## Final Mitigation Plan Monkey Wall Project

**DMS Project #: 100069 | Contract #: 7536 | USACE Action ID: SAW- 2018-01162  
DWR Project #: 20181029 | RFP: 16-007336**

Re: NCIRT Review and USACE Approval of the NCDMS Monkey Wall Mitigation Site / Mitchell Co./ SAW-2018-01162/ NCDMS Project # 100069

**SUBJECT:** Monkey Wall Mitigation Site - NCIRT Comments during 30-day Mitigation Plan Review

**CHANNEL BACKFILL**  
NTS

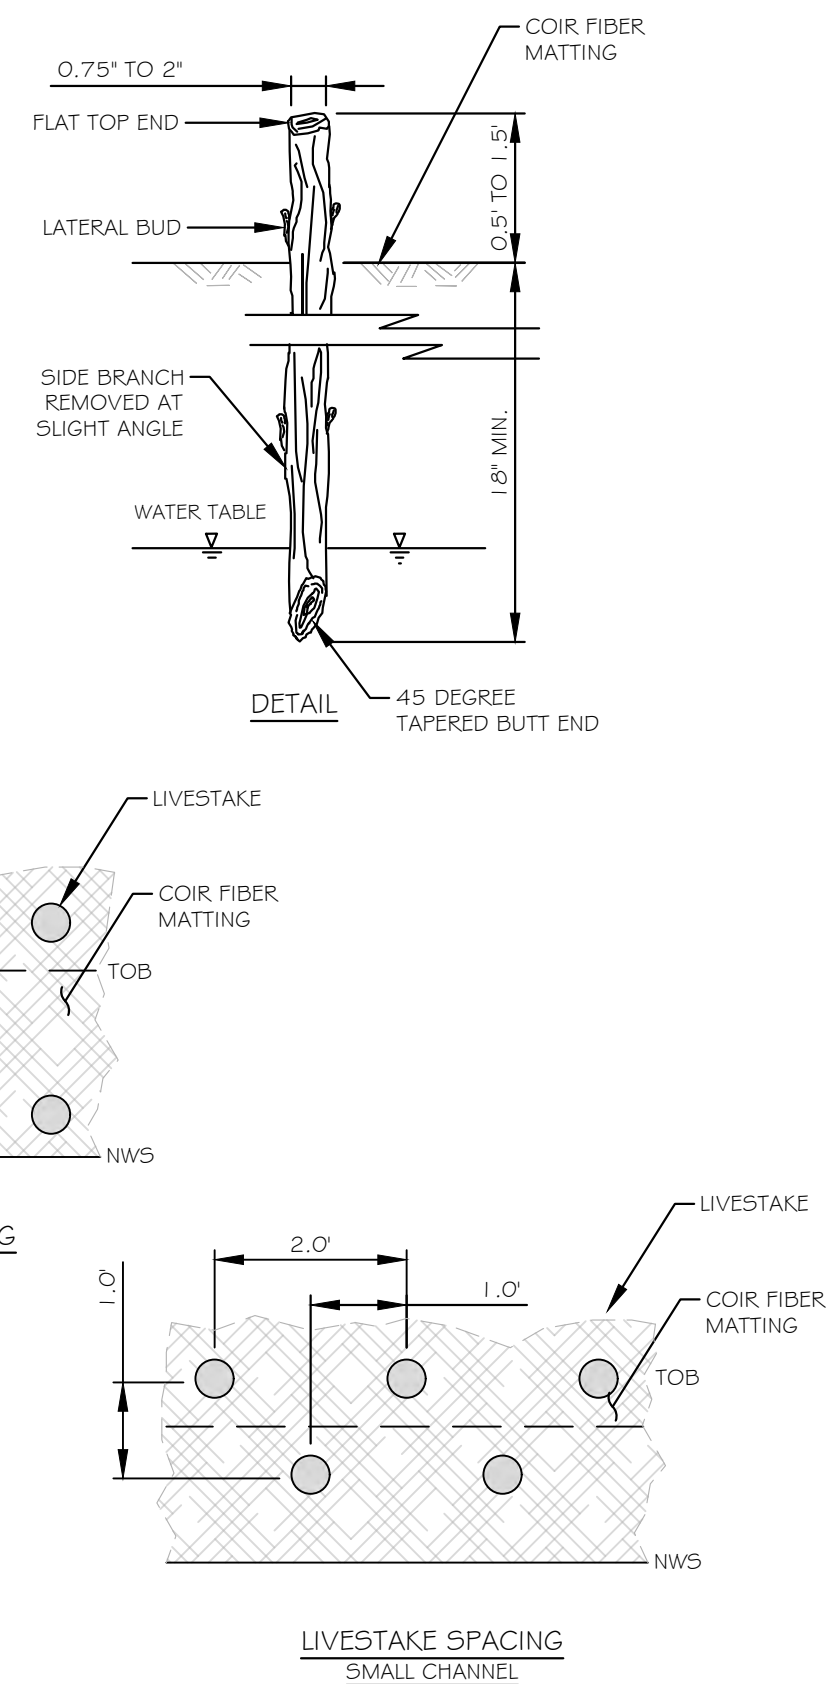
8. Design sheet D3- in order to alleviate problems of the previous two comments, DWR strongly recommends closely adhering to 12 inch compacted lifts shown in the channel backfill detail.

8. Design sheet D3- in order to alleviate problems of the previous two comments, DWR strongly recommends closely adhering to 12-inch compacted lifts shown in the channel backfill detail.  
As noted in 5 & 6 above, RES does not anticipate issues with loss of groundwater if the old channel is filled/plugged per plan.
